T10/07-321r2

To INCITS T10 Committee **From** Michael Banther, HP **Subject** ADT-2 Negotiation State Machine **Date** 17 September 2007

Figure 5 – Link Negotiation State Diagram

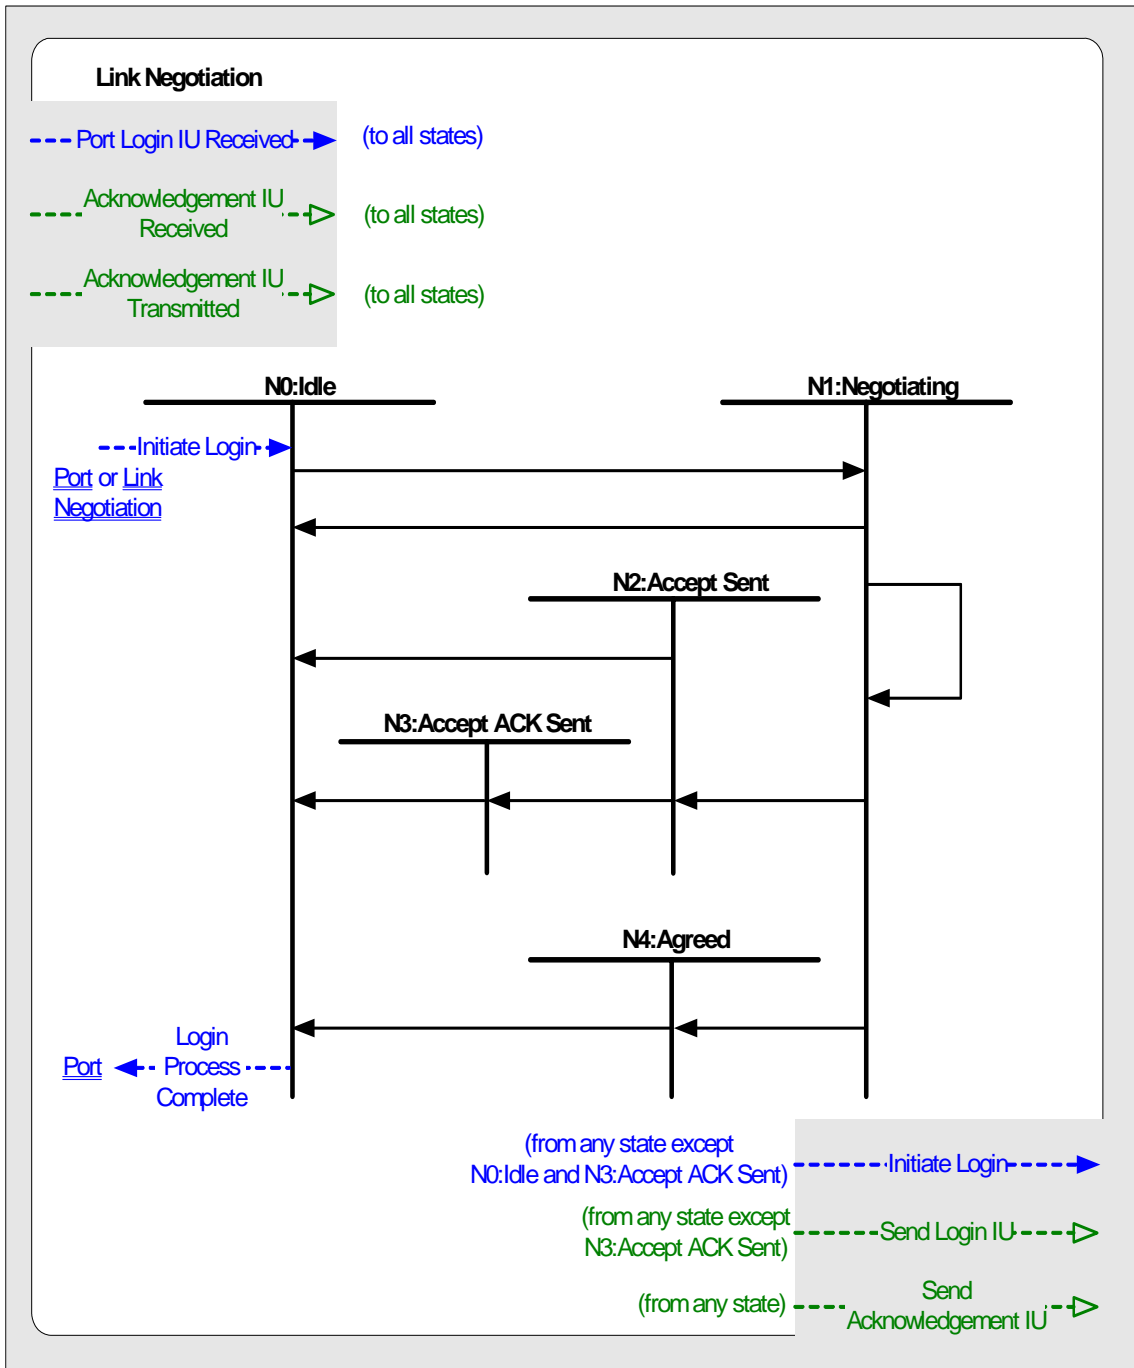
EDITORIAL NOTE: Figure 5 includes the following additions:

- a) A transition arrow from N1: Negotiating state to N0: Idle state;
- b) A transition arrow from N1: Negotiating state to N1: Negotiating state;
- c) A transition arrow from N2: Accept Sent state to N0: Idle state; and
- d) A message arrow for the Initiate Login message located in the bottom right-hand corner and annotated as from any state except N0: Idle and N3: Accept ACK Sent.

Figure 5 includes the following deletions:

- a) The transition arrow from N2: Accept Sent state to N1: Negotiating state;
- b) The transition arrow from N4: Agreed state to N1: Negotiating state.

Figure 5 includes the following change: the state machine name of the Initiate Login message that terminates at N0: Idle state reads, 'Port or Link Negotiation'.
